INDIANA DEPARTMENT OF TRANSPORTATION

APPROVED MINUTES

November 14, 2018 Standards Committee Meeting

RE: Minutes from the November 14, 2018 Standards Committee Meeting

E 610-DRIV-02 CLASS II DRIVE (WITH MARKUPS)

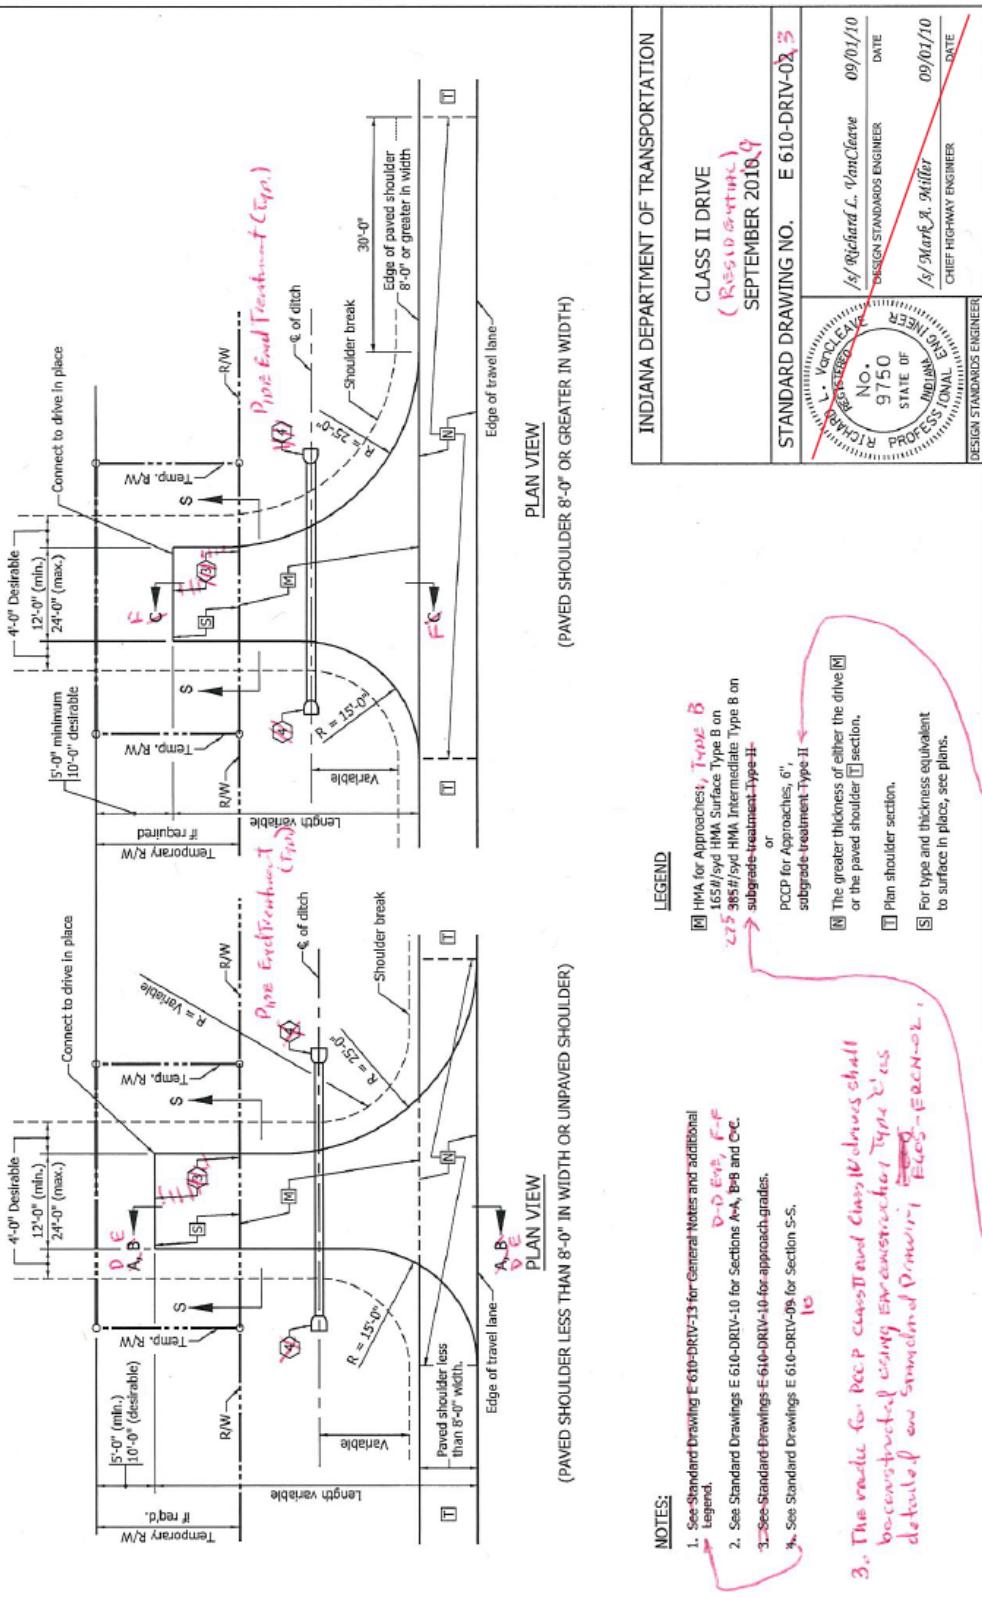
REVISION TO STANDARD DRAWINGS

E 610-DRV-13 CLASS VII DRIVE APPROACH GRADES (REVISED DRAFT)

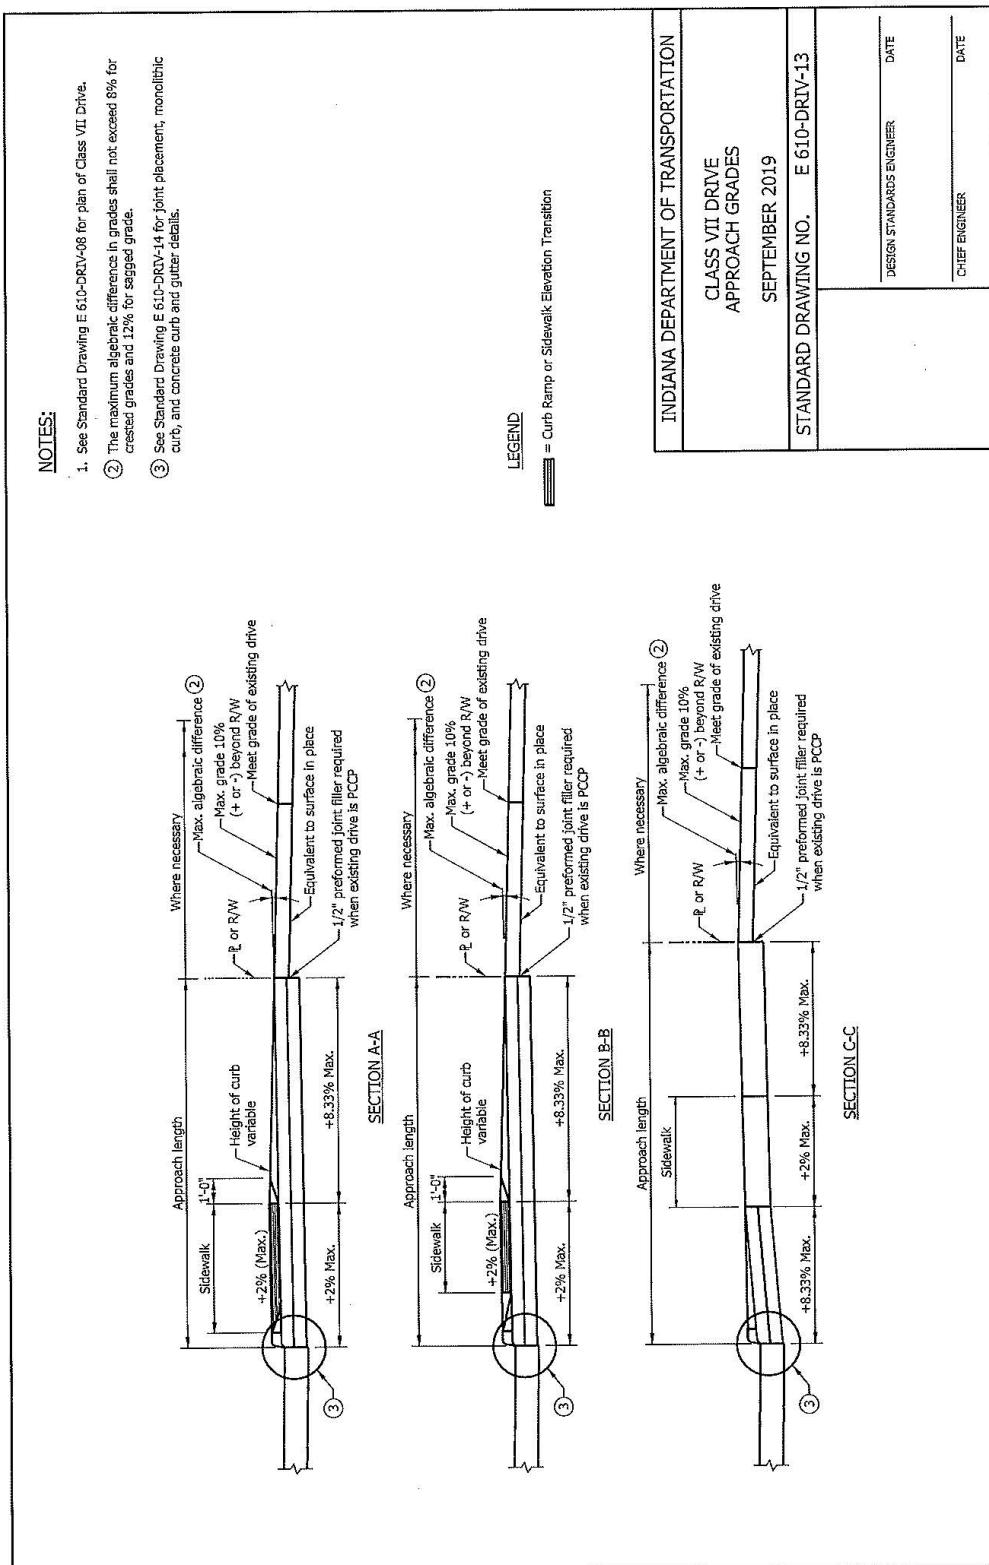
Mr. Koch also asked, with regard to 610-DRIV-09 and 13 - Should we reinforce the less than maximum slope concept for sidewalks crossing approaches, noted on plan views by referring 604-SDWK-03; 1.5% slope desirable? Mr. Orton responded that they'd prefer to let the sidewalk curb ramp standard drawings cover those specifics. Mr. Koch also asked, with regard to 610-DRIV-15; Are D-1 joints needed "3" if a 1 in. expansion "5" is also to be installed? Mr. Orton stated that D-1 joints will only be required on the commercial crossovers. The private drive will only have a longitudinal joint. Mr. Dave stated that the Department does not use keyway construction joints anymore...so only longitudinal joints will be used.

E 610-DRIV-16 PRIVATE AND COMMERCIAL DRIVE CROSSOVER SECTIONS (REVISED DRAFT)

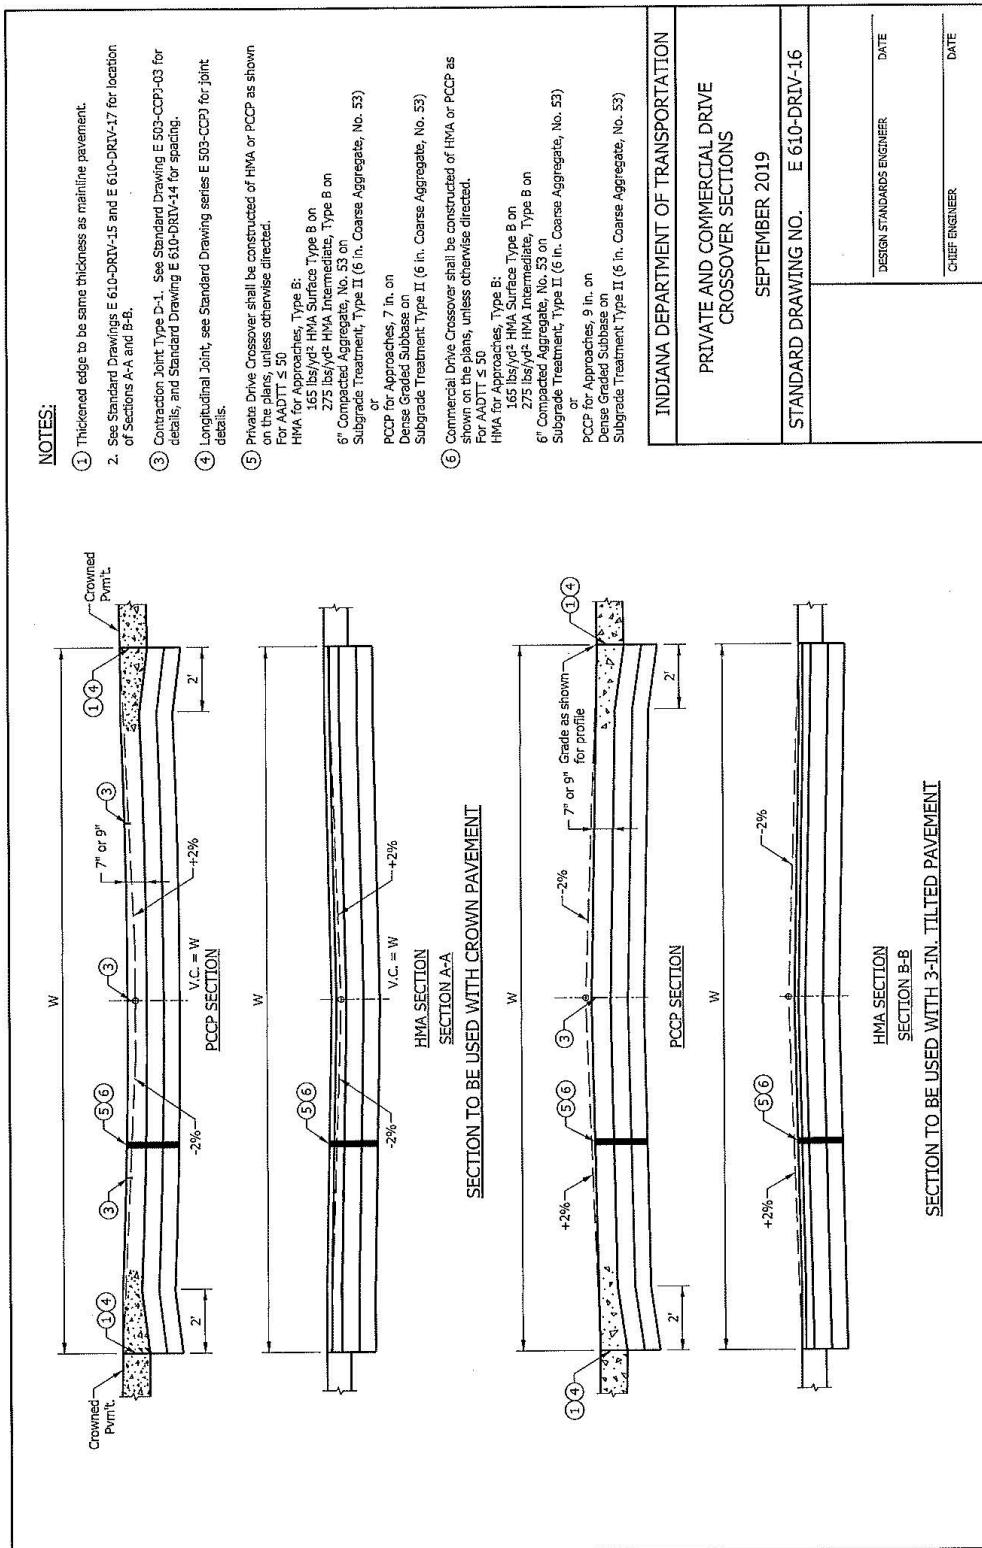
Mr. Koch further inquired about 610-DRIV-16 and 17 - stating that the plan note 4 is referencing the same drawing. Would 610-DRIV-14 be the correct reference?
